Ford

Fiesta, KA, Puma 1995-

CLTB 0007

MODIFICATION TO FORD CSC ref.BCS126

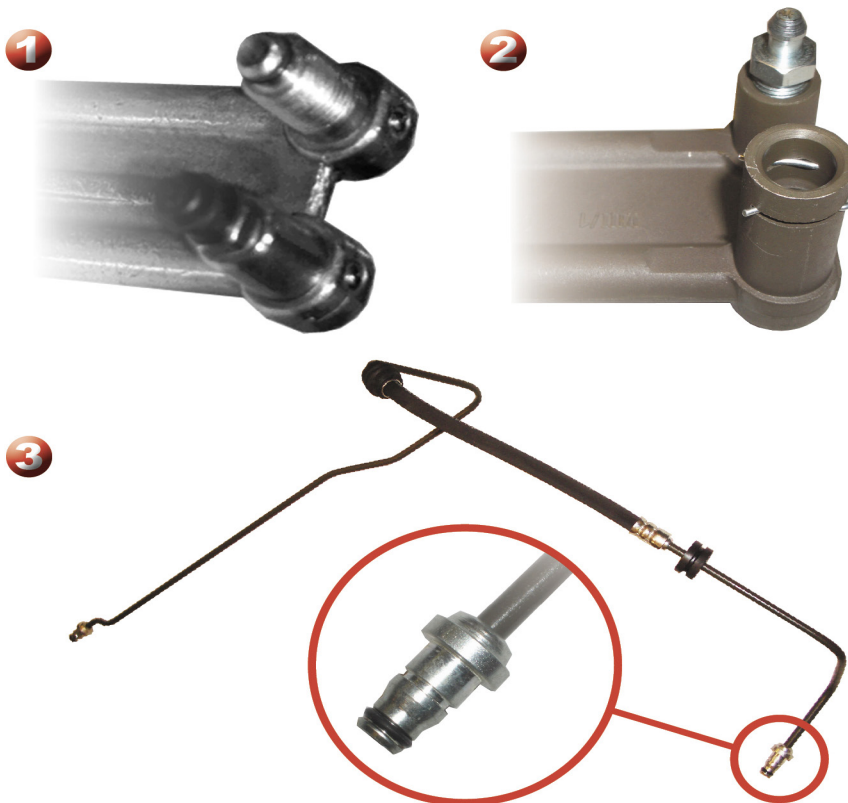
The vehicles listed above were originally fitted with a Concentric Slave Cylinder (CSC) incorporating a screw fit hose connection (1).

From 1999 the original fitment CSC design was modified to include a push-on (quick-fit) hose connection (2). Consequently, any replacement CSC will be of this later design and will require a matching hose with male push-on fittings (3).

This later type hose is available from Borg & Beck: HKD0001 Ford Ka

HKD0002 Ford Fiesta / Puma
